## Recall Repair Instructions

**NHTSA Recall # 25V-905**

**Tiffin Motorhomes Recall # WAY-106**

**Purpose:** To swap the inverter to battery harness for the Open Trail units to ensure proper functionality and wire conductivity.

Figure 1

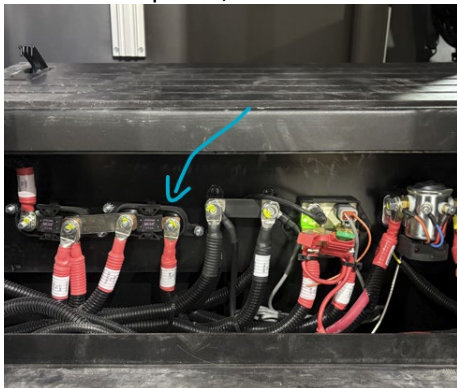
1. Locate the step well and remove the access panel from the step area to reveal the harness connection point to the fuse. Locate the inverter to battery harness located beneath the step well, see figure 1. This harness runs from the step well, across the coach and into the battery box beneath the furniture.

Figure 3

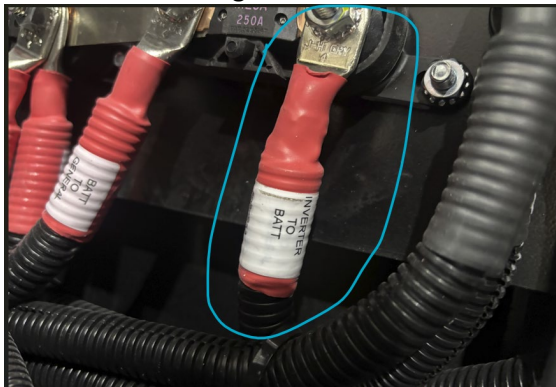
2. The incorrect wire harness will be labeled with part # 5060954, see figure 3. The correct wire harness will be labeled with part # 5185602.
3. If the correct harness part # 5185602 is installed, please file a warranty claim to clear the recall from the motorhome. If the incorrect harness part # 5060954 is installed, proceed with repair instructions below.

4. With power off to the coach, remove the terminal connection for harness, labeled INVERTER TO BATT 5060954. Remove the existing harness from the underbelly and properly dispose of.

7. Install the new inverter to battery harness, part # 5185602, and route through existing wire pathway. Reconnect the harness to the inverter and torque to 106 in-lbs.
8. Reconnect the other end of the harness in the step area to the terminal lug. Torque to 110 in-lbs.
9. Reassemble all removed components. Reinstall any removed trim and access panels, being careful not to overtighten or strip the fasteners. Reconnect chassis battery cable and the access panel.
